**Environmental
Planning
Commission**

**Agenda Number: 06
Project Number: 1004075
Case Number: 17EPC-40049
Hearing Date: November 09, 2017**

Staff Report

Agent	Dekker/Perich/Sabatini (DPS)
Applicant	Land Advisors Organization, LLC
Request	Text Amendments to the Mesa del Sol Level B Community Master Plan Tracts 6, 7, and 14, Bulk Land Plat of Mesa del Sol (Parcel 1); Tract 12-B, Plat of Tracts 12-A & 12-B, Mesa del Sol, Innovation Park (Parcel 2); Lots numbered 5, 6, 13, 14, 15, 17, and 25 of Bulk Land Plat of Mesa del Sol, Innovation Park (Parcel 3); Tracts lettered F, J, K, L, M, N, O, P, R, OS-1, OS-2, OS-3, OS-4, OS-5, OS-6, and OS-7, Bulk Land Plat for Mesa del Sol Innovation Park II, a replat of Tracts 1, 12, 15, 4-A-2, 4-A-3 and 4-A-4, Mesa Del Sol, and Tracts 2-A, 2-B, 3, 4, 7, 8, 9, 10, 16, 18, 19, 20, 21, OS-1, OS-2, OS-3, and OS-6, Mesa del Sol Innovation Park)(Parcel 4); and Tract lettered 'I-2' Mesa del Sol Innovation Park II (a replat of Tract "I", Mesa del Sol Innovation Park II) (Parcel 5); zoned PC (Planned Community), located east of Broadway Blvd. and south of Los Picaros Rd. SE

Current Regulations vs. Proposed Regulations: Impact on residential subdivision layout

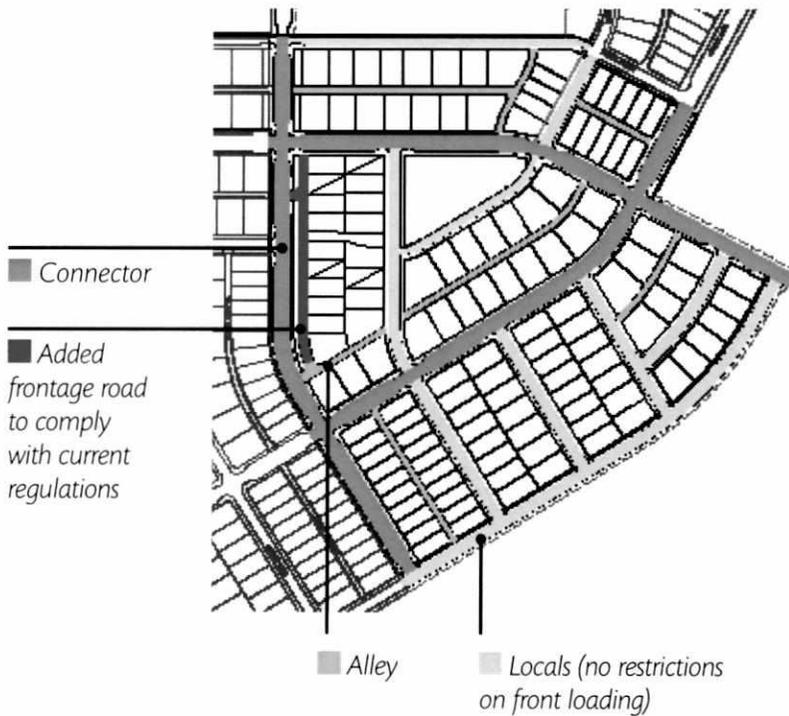
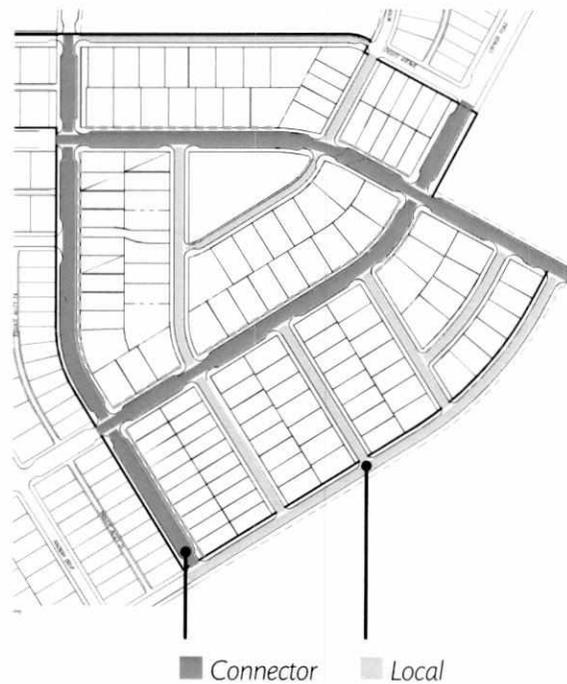
The two maps illustrate what has been approved under the current regulations (left) and how the same area could be designed under the proposed regulations (right).

Note:
 This subdivision layout is not a proposed plan, but is for illustration purposes only, assuming 100% of the lots on Connector roads are front loaded.

- Same number of lots
- 10 additional front-loaded lots with no ally design
